ECE/TRANS/WP.29/GRSP/2008/24
26 September 2008

REGULATION No. 17
(Strength of seats)

Alignment to gtr No. 7 head restraints

Submitted by the expert from Japan */

Figure 9-1 Video motion target placements

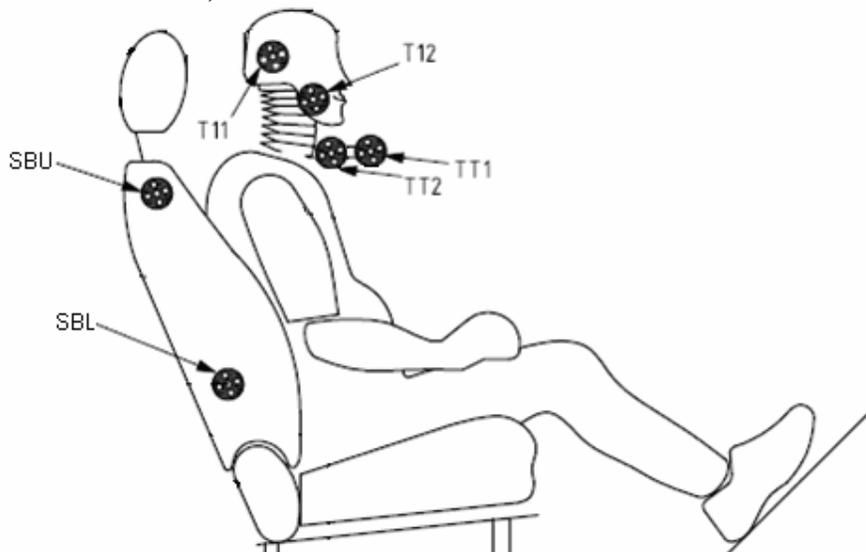
3.2.2. Film targets, as described in Figure 9-1 and Table 9-1, shall be applied on both sides of the head, T1 bracket and seat back.

Figure 9-2 Proper positioning of the test dummy's feet.

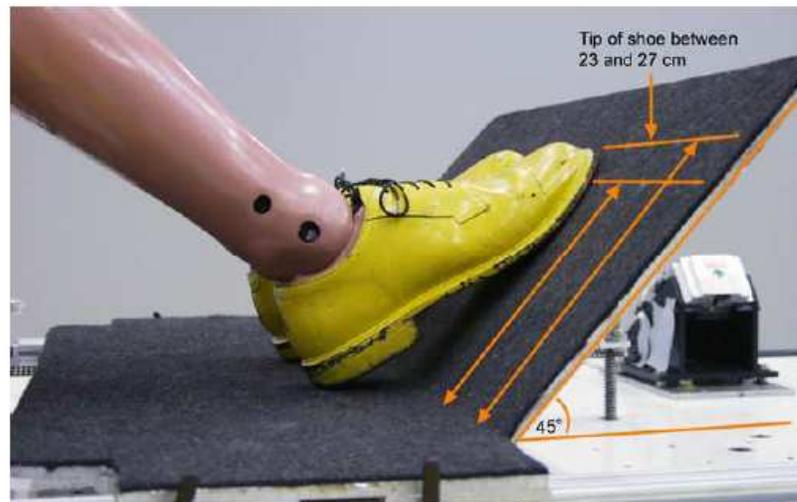
- 4.7.5. Position the test dummy's H-Point 20 ± 10 mm forward and 0 ± 10 mm vertically of the H-Point location measured under the condition specified in paragraph 2.12. of Annex 4, while keeping the pelvis angle at 26.5 ± 2.5 degrees.
- 4.7.6. Adjust the spacing of the legs so that the centreline of the knees and ankles is 200 mm (± 10 mm) apart and ensure that the knees are level.
- 4.7.7. Adjust the test dummy's feet and/or the horizontal position of the adjustable toe board so that the heel of the test dummy's shoe is resting on the heel surface. The tip of the shoe shall rest on the toe pan between 230 mm and 270 mm from the intersection of the heel surface and toe board, as measured along the surface of the toe board (see Figure 9-2).

Figure 9-3 Spine curvature check

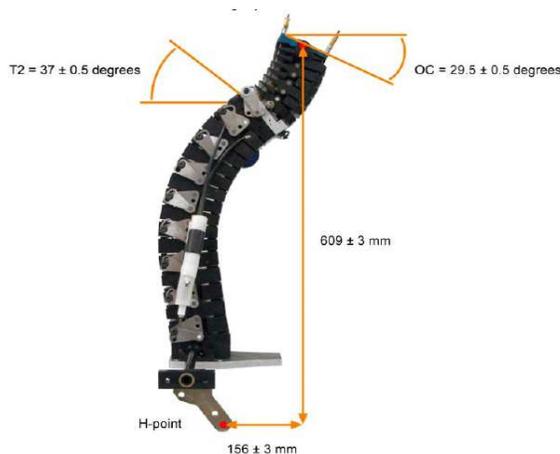
With the pelvis adapter plate placed on a level surface with the occipital condyle (OC) angle at 29.5 degrees (± 0.5 degrees), the T2 angle at 37 degrees (± 0.5 degrees), and the neck plate laterally level (± 0.5 degrees), the distance in (X) between the H-Point and the OC pin shall be 156 mm (± 3 mm) and the distance in (Z) between the H-Point and the OC pin shall be 609 mm (± 3 mm) (See Figure 9-3). The curvature check shall be performed after every 15 tests and all measurements shall be recorded and fully documented.

Figure 9-4 – Sled pulse acceleration corridor."

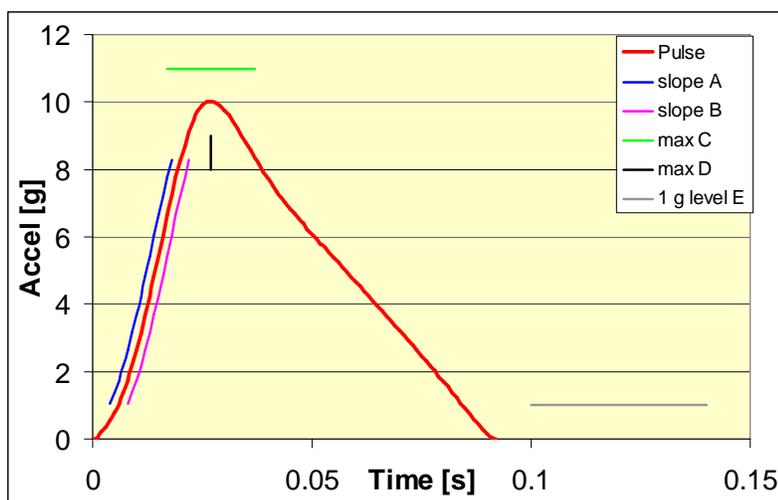
5.1. The sled acceleration shall be adjusted as close as possible to the target curve and within the blue corridors in Figure 9-4 for the complete time interval from 0 to 0.15s. The sled pulse shall fulfill the requirements as specified in Table 9-2.
